Genser-Forman Inc. TRIUMPH DISTRIBUTORS

TO: ALL DEALERS
DEPT: SERVICE & PARTS

BULLETIN: T-62-9
DATE: AApril 19, 1962
SUBJ: TRIUMPH HERALD
HORNS

FIG. 1

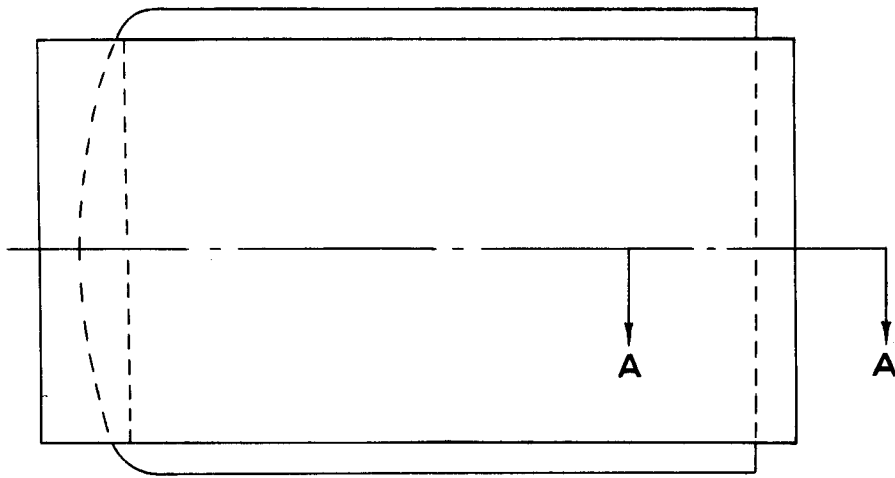
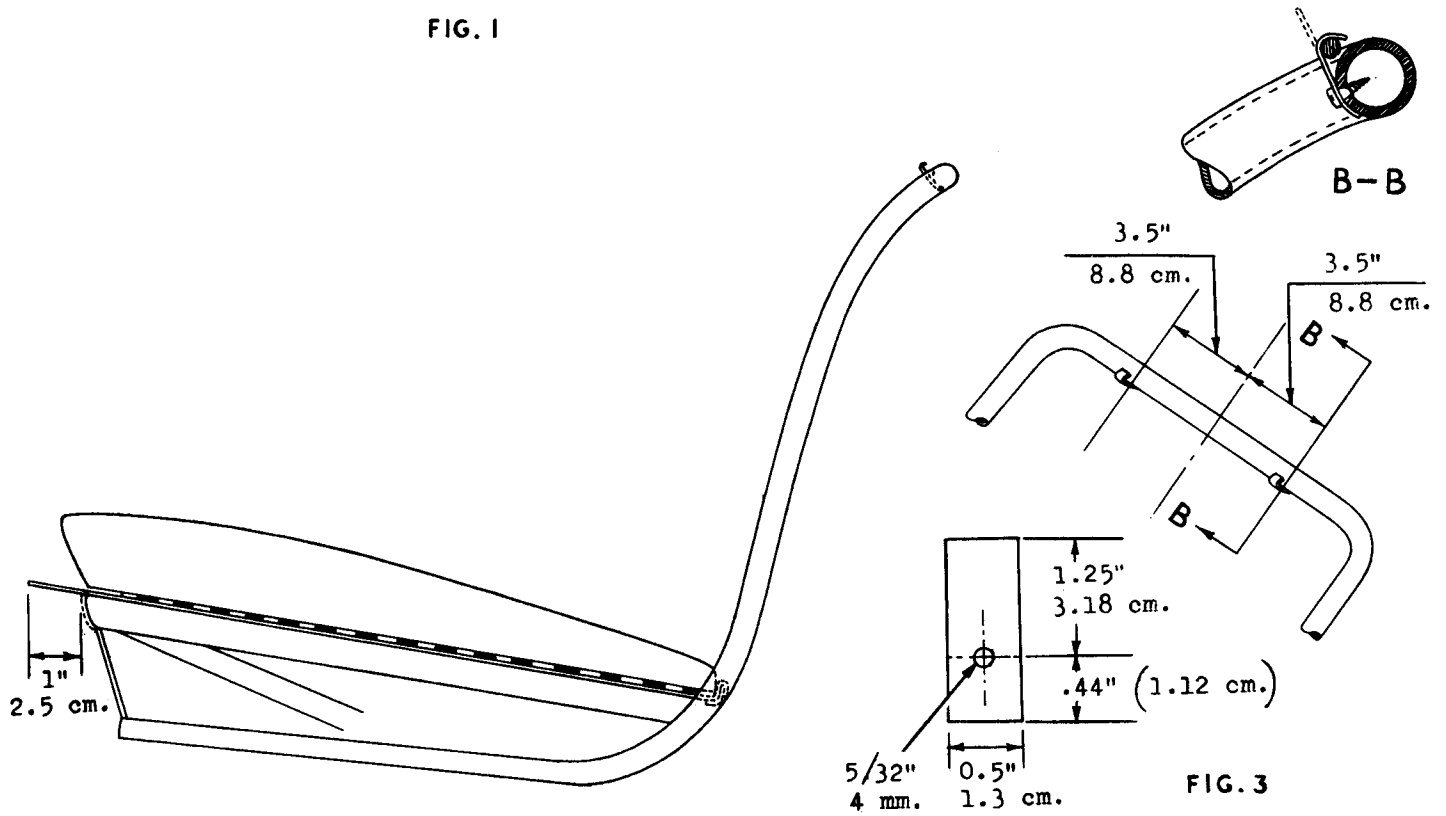
A revised method of fitting the seat squab pad and spring case has been introduced, which may be employed in service where complaints of sagging squab and cushions are received.

Remove squab trim and seat cushion.

SUBJ: TR-4 FRONT SUSPENSION
SPECIFICATION CHANGE

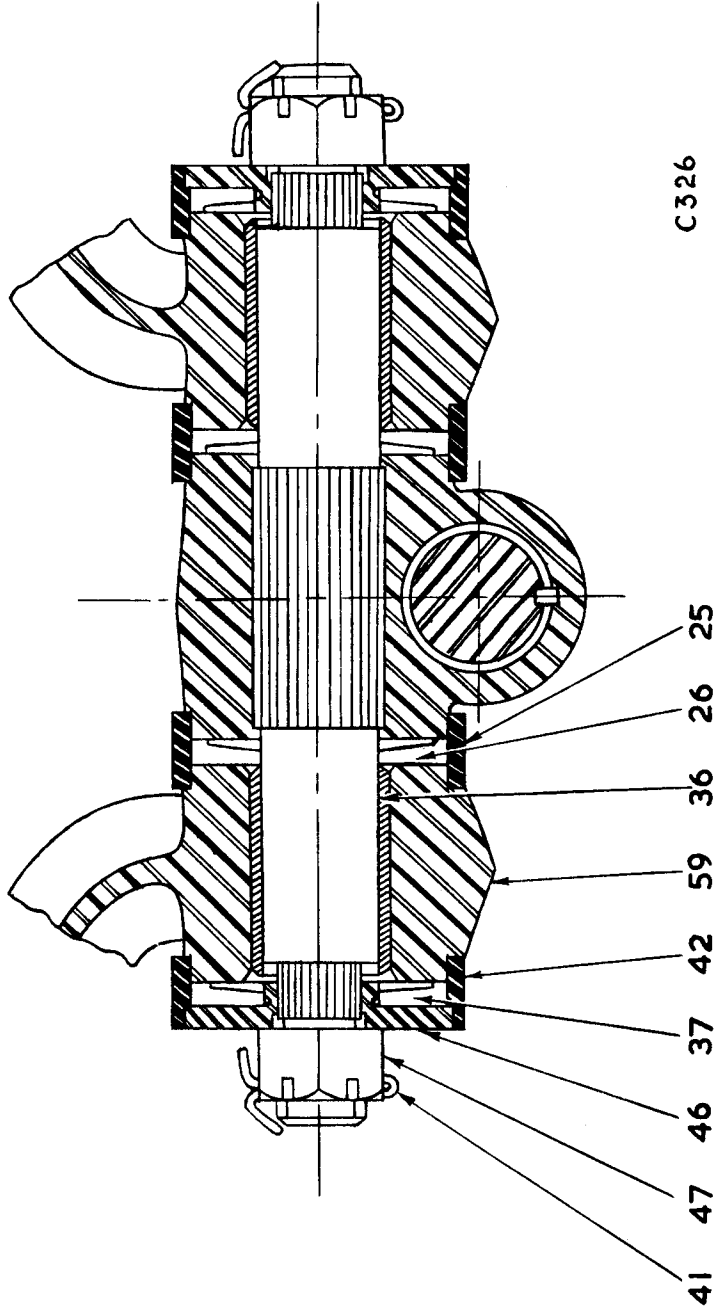
The correct procedure for assembling the lower suspension parts to the trunnion is as follows:

1. Assemble the parts as shown in the illustration.
2. Equally tighten each nut (47) to maintain the correct relationship between the pivot and the bronze trunnion.
3. Continue tightening the nuts equally, to an initial torque load of 30 lb.ft. This permits the outer washer (46) to be serrated by the self cutting splines and located against the thrust washer (37)
4. Slacken the nuts and retighten to a torque load 5lb.ft.
5. Slacken the nuts by $1\frac{1}{2}$ to 2 flats to suit split pin insertion and to permit $0.004'' - 0.012''$ end float in the bearing.
6. Check the assembly for freedom of movement over its full range of operation. Readjust if necessary.
